File #: O2023-1551, Version: 1

SUBDIVISION ORDINANCE

Re: Proposed Subdivision Ordinance 3rd and 4,h Wards

OUC File No. VD-108179

EXHIBIT "A""

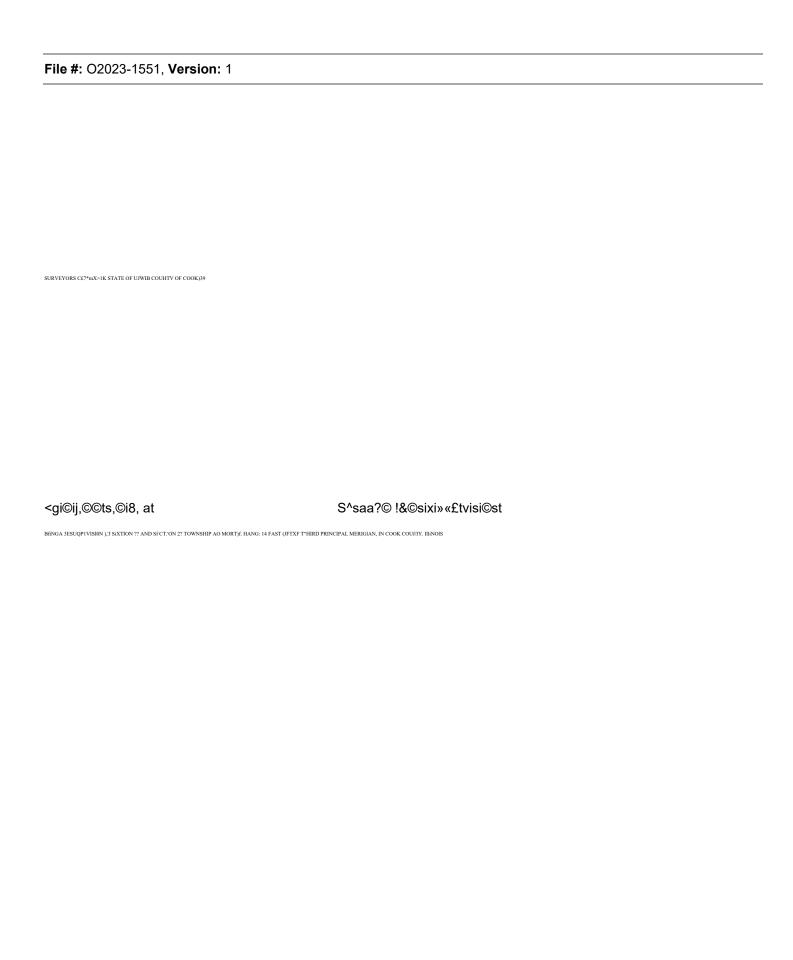
The Plat of Subdivision dated September 9, 2022 shows easements reserved for water. The easements are subject to the conditions in Section III.

Per Exhibit "A" titled McCormick Subdivision, there is a total of twenty-three (23) proposed lots represented as Lot 1 through Lot 23.

PUBLIC SEWERS TO BE MAINTAINED BY THE CITY: Based on sewer records, the following public sewers and associated structures are present within the area proposed for subdivision. These sewers must be retained and maintained.

See Section III for detailed conditions for the easements for these sewers.

PRIVATE SEWERS TO BE MAINTAINED BY METROPOLITAN PIER AND EXPOSITION AUTHORITY (MPEA): Based on sewer records, the following sewers are serving private properties within the area proposed for subdivision. To approve the proposed subdivision, the beneficiary must assume ownership of these sewers and appurtenances along with any existing flow, which may exist from the area outside of the proposed subdivision. These sewer facilities will be private property of the beneficiary. The beneficiary must

The Department of Water Management (DWM) will approve the proposed subdivision, provided all existing easements for the above sewer and water facilities must remain. For any sewer and water facilities listed above without an existing easement, the beneficiary must agree to provide new easements with the conditions below:

a) For sewers with a diameter of 42" and smaller, there must be a reservation forty (40) feet wide centered at the centerline of the existing public sewer. For sewers with a diameter of 48" and larger, there must be a reservation sixty (60) feet wide centered at the centerline of the existing public sewer.

- b) For all water mains, there must be a reservation forty (40) feet wide centered at the centerline of the existing water main.
- c) There must be a minimum of forty (40) feet of vertical clearance from ground level to provide access to construction machinery that would be necessary in the event of a break or if maintenance or relocation were required in the future. For locations under existing structures, the easement must extend vertically to the existing structure above.
- d) No temporary or permanent buildings or other structures shall be erected upon or over the areas where reservations are required.
- ■e) The DWM must have continuous 24-hour access without any obstructions like fences or bollards to the area where the reservations are required.
